IEEE P802.11

Wireless Access Method and Physical Layer Specifications

Title: Making Hash, or
A proposed change to Sections 4.1.5 and 5.2.12 in the draft IEEE p802.11-93/20b1

Figure 4-xx Octet Assignment for MPDU-ID Procedure

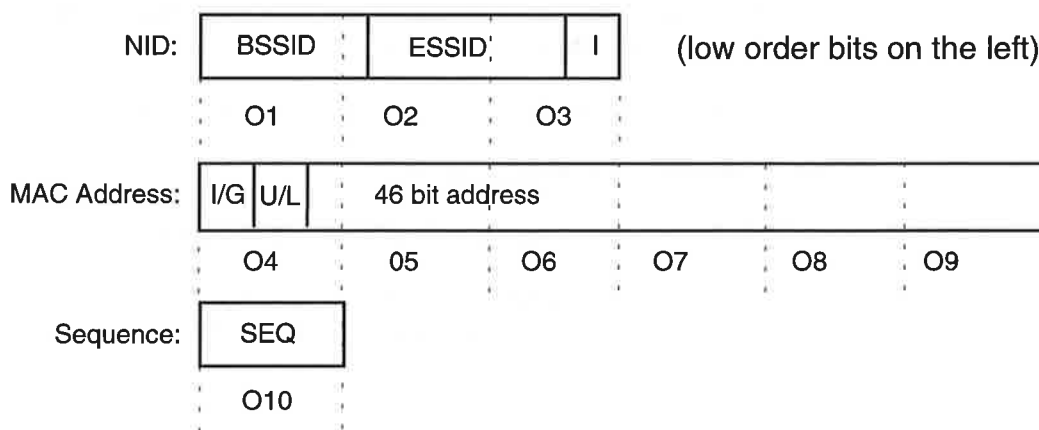
These source data are divided up into octets, which are numbered as shown below in figure 4-xx.

In any given installation, it may be expected that the MAC addresses will reflect the manufacturer's ID of only a small number of vendors, therefore O8 and O9, as shown above are the most likely components to vary from one MPDU ID to the next, with O9 having the most variability.

In practice, an implementation of a MAC is likely to reject frames which do not have the same NID as that STA at a very low level, and will not cache the MPDU ID for those frames. Therefore, the NID components of MPDU ID, O1, O2 and O3 are highly unlikely to vary.

Figure 4-xx, Integer Construction for MPDU-ID Procedure

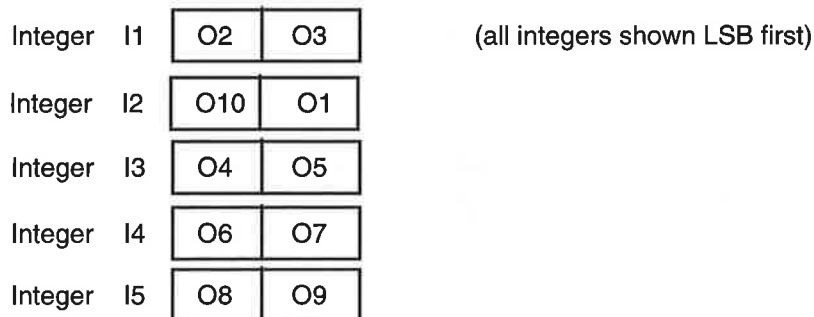
Integers are constructed from the ten octets in the source fields as shown in figure 4-xx.

The MPDU ID is constructed in such a way as to distribute the components which vary with the highest probability across all the bits of the MPDU ID.

The MPDU ID shall be defined as:

$$\text{MPDU ID} = I1 + I2 + I3 + I4 + I5$$
